Product Change Notification—PCN# PCN001070

We would like to inform you that Moxa is going to make changes to the SDS-3008 and SDS-3016 Series. Please review the details below to determine how these changes will affect your products and/or operations.

Current Version	New Version

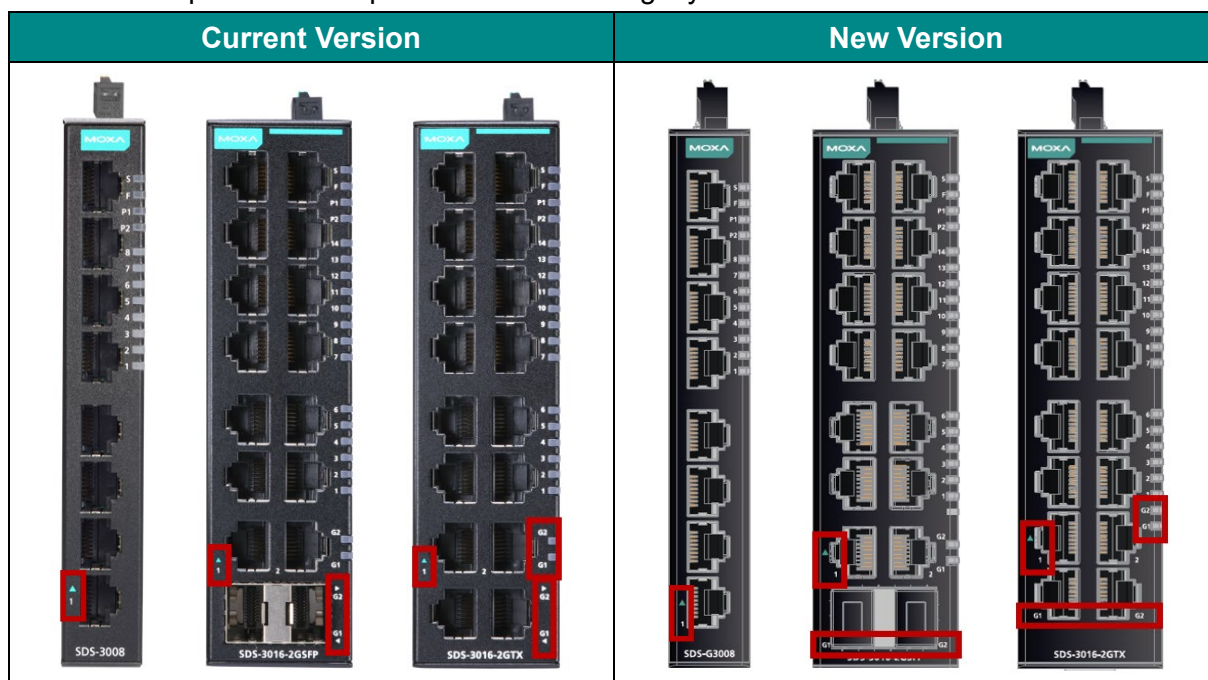
- The rotary DIP switch will be added to the bottom of the SDS-3008 Series to align with the design of the new SDS-3000/G3000 Series and provide an easier configuration option.

- A one-side screw will be added to the terminal block to provide better reliability. The current terminal block is compatible with the new top panel design.
